## Technical change to PV - STICK

| • PCN-number:           | PCN-PB43-210127-00-A |

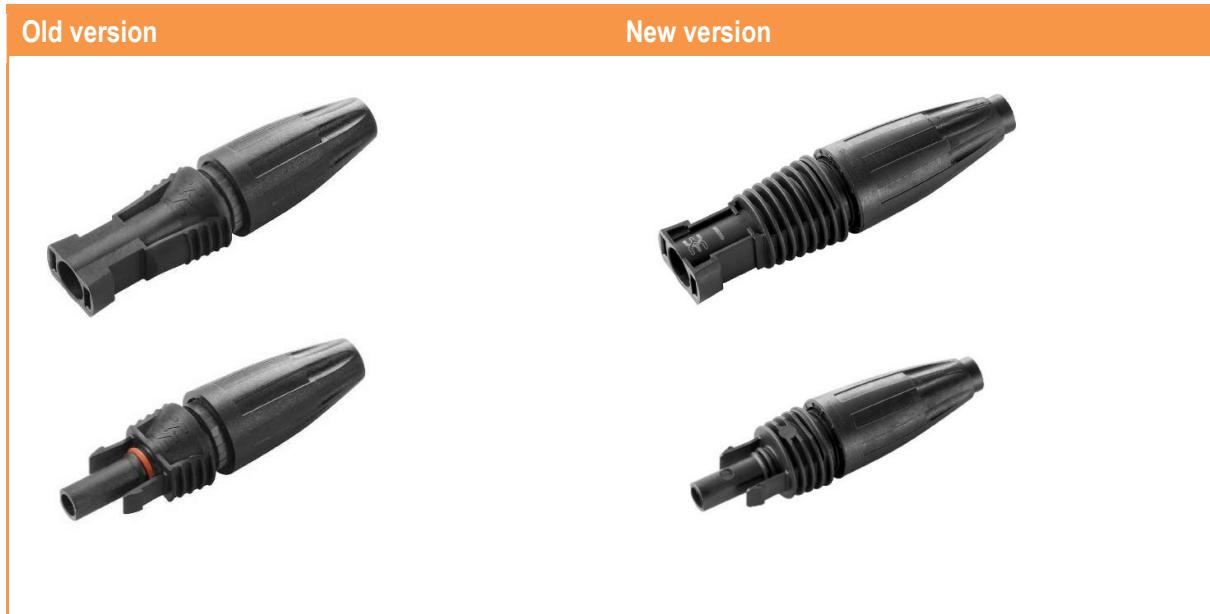
- The design of the PV-Stick has been adapted.
- A new TÜV certification number has been assigned.

- The changeover will be done until end of the first quarter 2021.
- Both versions are plug-in and assembly compatible with each other and can be used together.
